## SERVICE BULLETIN 19-03-22

**Subject:** Cracking of the EX-00017 Cylinder #2 Exhaust

**Affected Models:** RV-12 with 912 ULS engines

**Figure 1: Cylinder #2 Exhaust Variants**

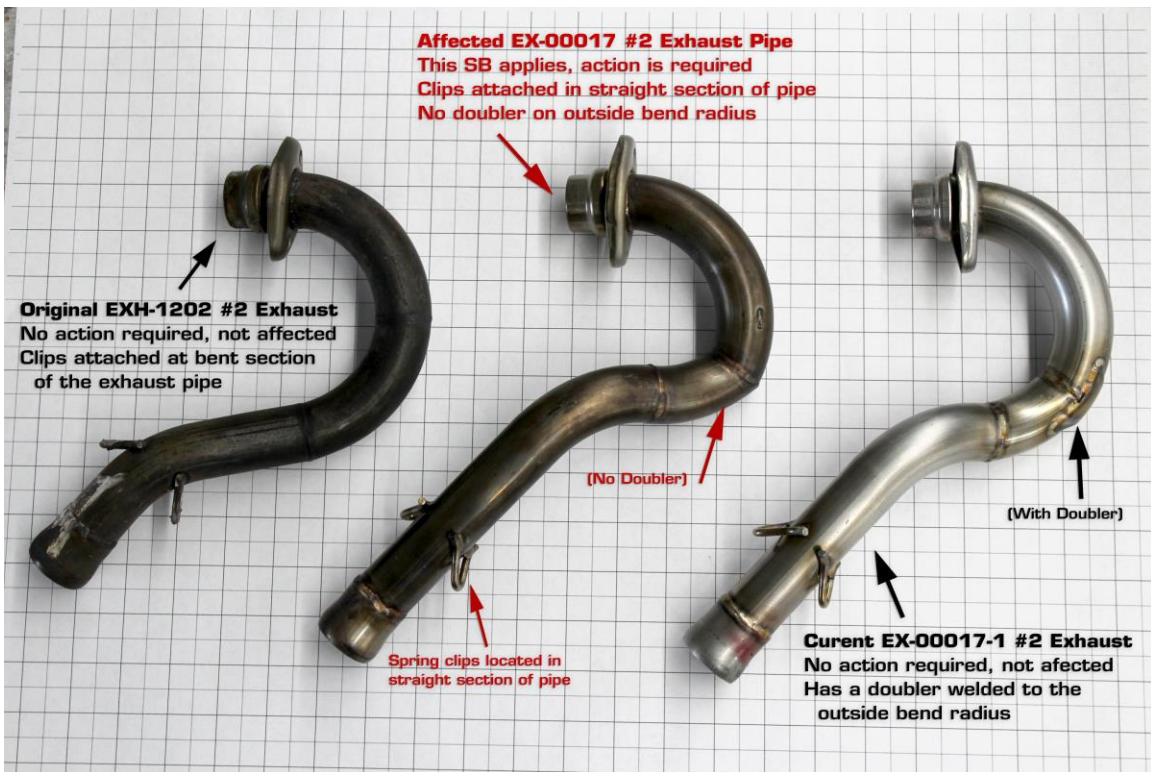
Step 2: Inspect the cylinder #2 exhaust to determine which part number is installed. See Figure 1.

- If an EXH-1202 or EX-00017-1 is installed, proceed to Step 8.
- If an EX-00017 is installed, proceed to the next step.

**Required Action:** Inspect the EX-00017 Cylinder #2 exhaust tube for cracks as described in this document. If cracks are found, replace the EX-00017 with an EX-00017-1.
